City of Sugar Hill  
Addendum to Planning Staff Report  
**RZ 16-002**

**DATE:** July 07, 2016  
**TO:** Mayor and City Council  
**FROM:** Planning Director  
**SUBJECT:** Change in Conditions RZ 16-002 – Bellagio Properties

City of Sugar Hill  
Planning Staff Report  
RZ 16-002

**DATE:** June 28, 2016  
**TO:** Mayor and City Council  
**FROM:** Planning Director *KA*  
**SUBJECT:** Change in Conditions RZ 16-002 – Bellagio Properties

**Z-1**

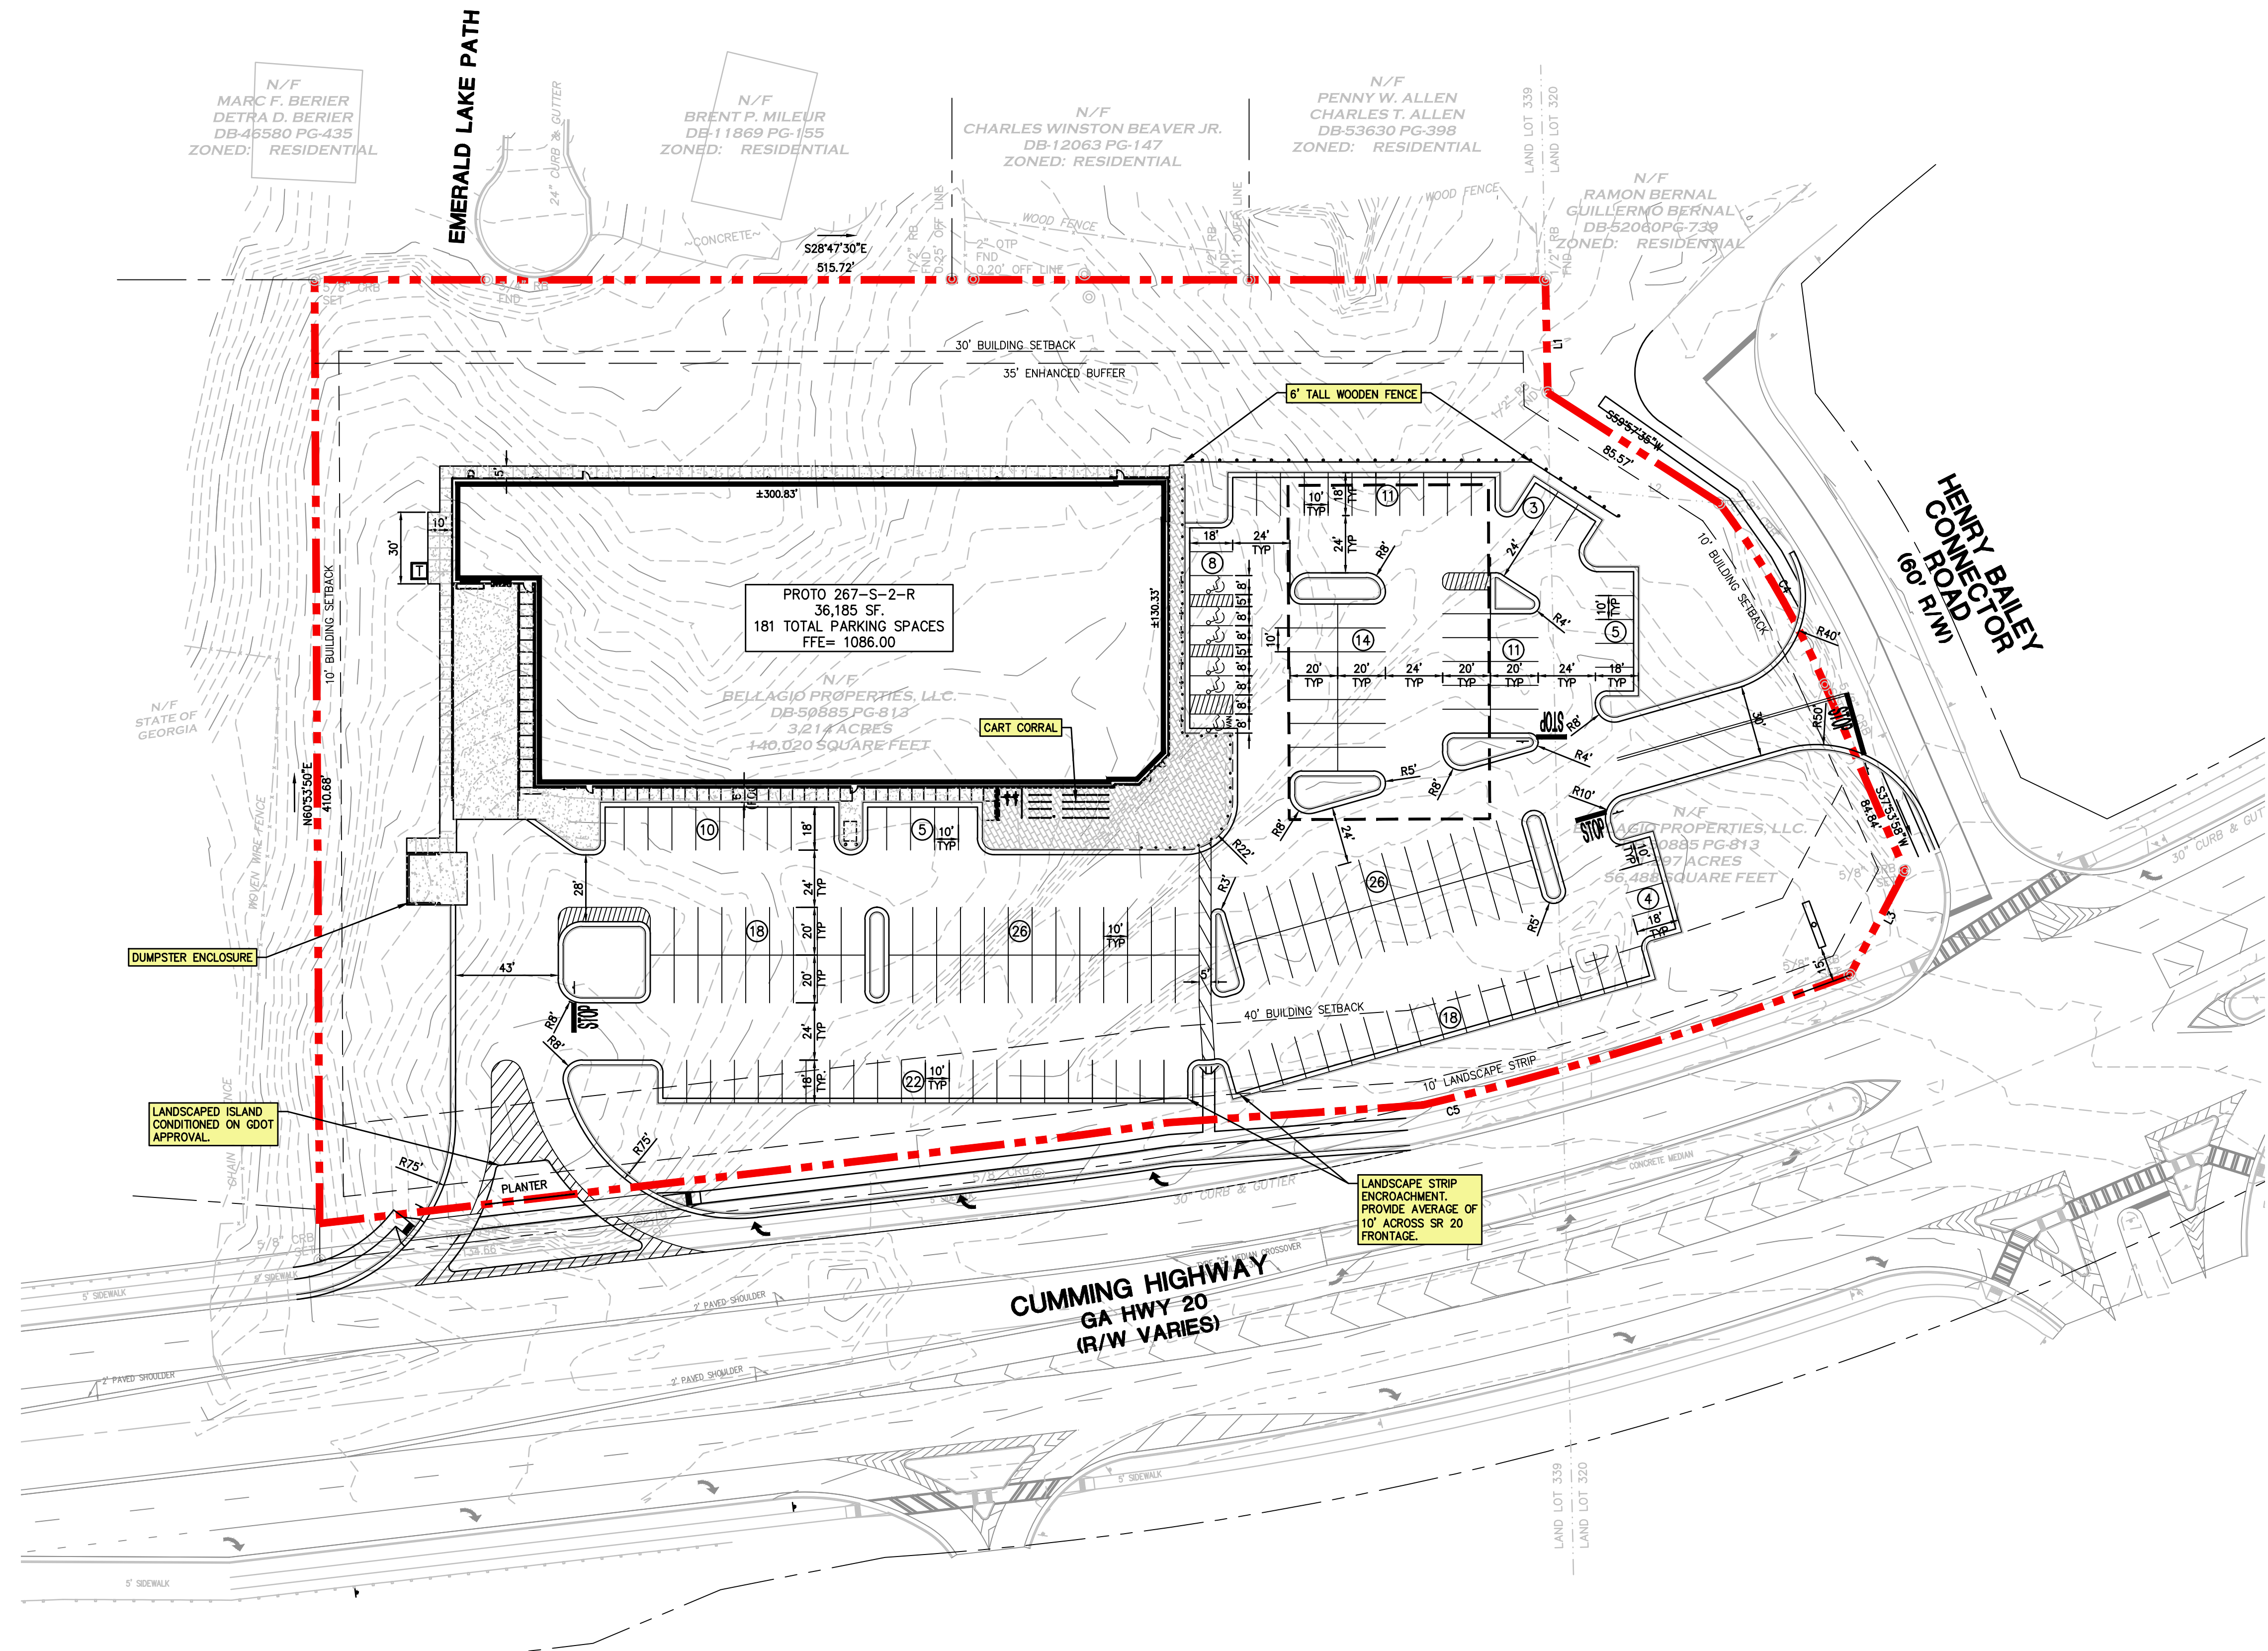
As we discussed, the issue with the loading dock and dumpster locations is their visibility to SR 20. From a noise perspective, it is our opinion that the current location is best suited to minimize the impact on the adjacent residences. Given the volume of vehicles on SR 20 and the noise associated with those vehicles, the noise impact from the dumpster and loading dock to the properties south of SR 20 should be minimal.

To address the aesthetics, the site plan has been changed to create larger landscaped areas around the perimeter of the Right-in/Right-out driveway and within the parking lot. Additionally, we are proposing to landscape the portion of the island within the Right-in/Right-out driveway that is outside GDOT's right-of-way with the condition that GDOT approves it. It is our opinion that the combination of the dumpster enclosure and the additional landscaping will substantially screen both the dumpster and the loading dock from SR 20.

- The location of the loading dock and dumpster do not meet the zoning ordinance requirements and face SR 20 and the front driveway entrance to the parking lot.

5. *The location of the dumpster enclosure and loading dock are approved per the site plan by W&A dated 6/3/16 provided the approval of the Landscape Plan by David Albright, dated 6/8/16.*

1 SOUTH ELEVATION  
A4.04 3/32 = 1'-0"

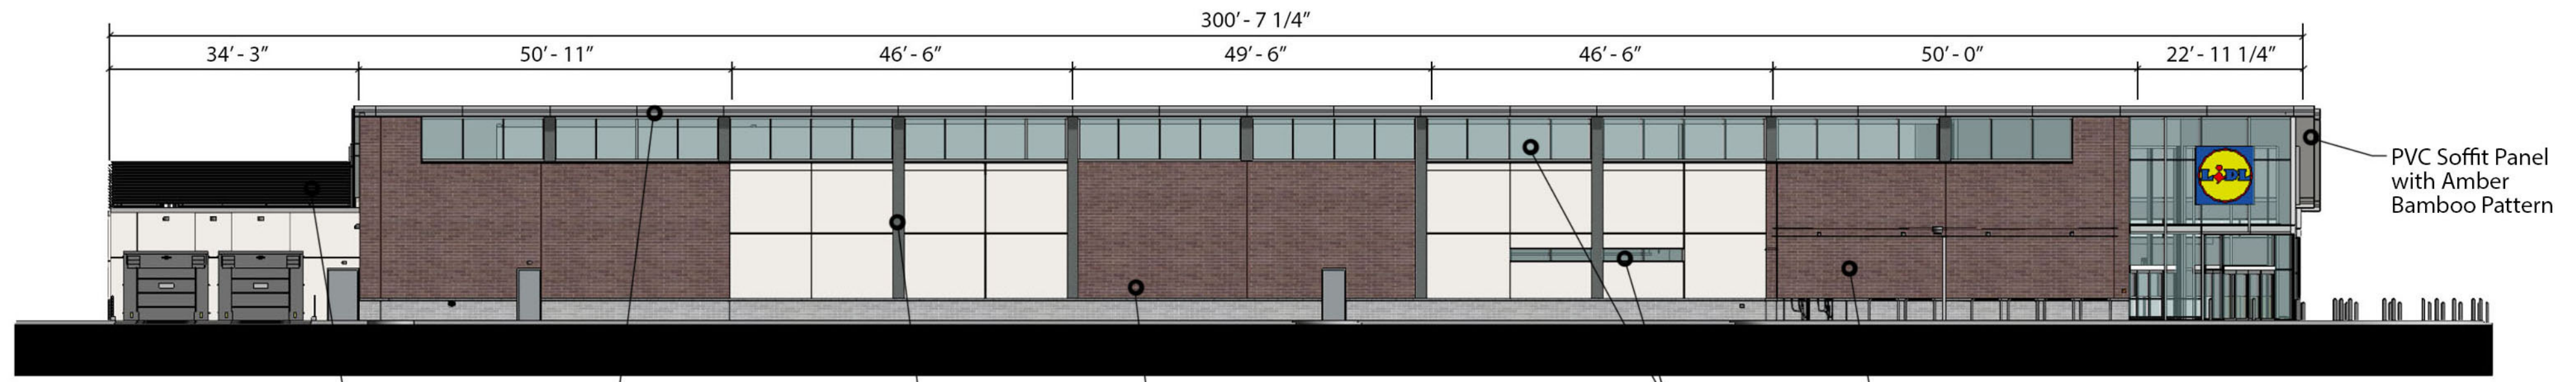
- The building does not display a clear hierarchy between service space and served (public) space. Due to the siting of the building on a corner lot, there are effectively two front facades (south and east). The south elevation (facing SR 20) includes a loading dock, service doors, and clerestory windows with a small amount of glazing located around 8-10’ height). The east elevation is primarily composed of a curtain wall. (from Sugar Hill Zoning Ordinance, page 10.12, “...utility/service areas shall be screened and incorporated into the design of the building and/or hidden from public view when viewed from any public space or street level.” And from Sugar Hill Zoning Ordinance, page 6.6 “Roll-up type cargo bay doors shall be limited to the side or rear of buildings located in OI, HSB, and BG zoning districts.”)

- The stucco elements on the south elevation appear to read as columns; however, they do not penetrate the Urban Gray brick to the ground and in several locations are only located on the clerestory window portion and therefore appear to read as joists. The spacing and regularity between these two elements are not regular, and the function and/or aesthetics of these architectural elements are unclear. (from Sugar Hill Zoning Ordinance, page 6.6, “Each building design shall be made up of a compatible combination of these traditional architectural elements or similar elements...prominent columns, posts, and/or pilasters...”)

3 EAST ELEVATION  
A4.04 3/32 = 1'-0"

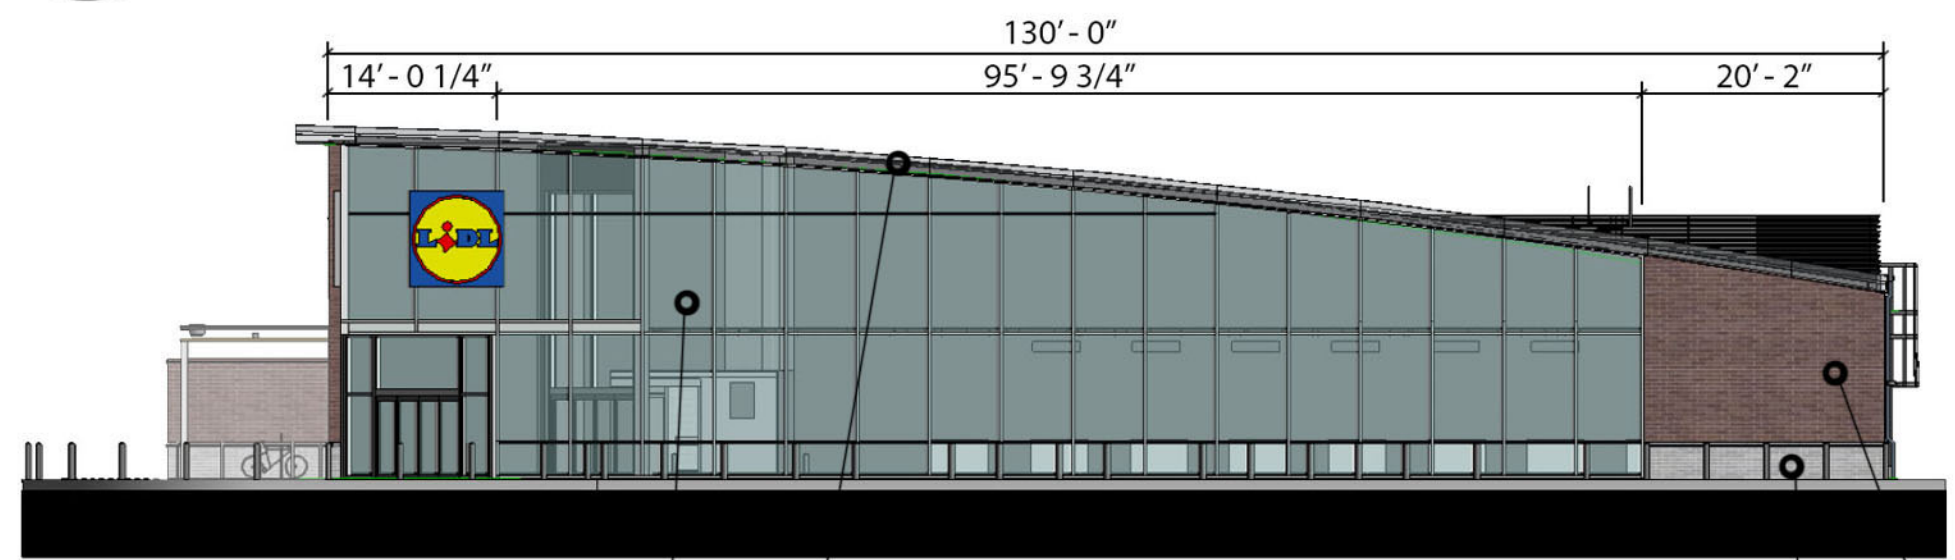
- Use of a façade segment greater than allowed. On both the east and west elevations, the total length of the façade is approximately 130'. An unbroken brick facade segment that is 85'-4" in length has been used on the west elevation, and an unbroken glass façade that is 95'-9 3/4" has been used on the east elevation (from Sugar Hill Zoning Ordinance page 6.9, "Building facades shall be visually divided into segments through articulation of the façade achieved by methods such as, but not limited to, variation in building materials, roof line, building setback, the use of additional window bays, pilasters, etc." The chart on this page shows that for 50'-150' length facades, the maximum segment length is 50')
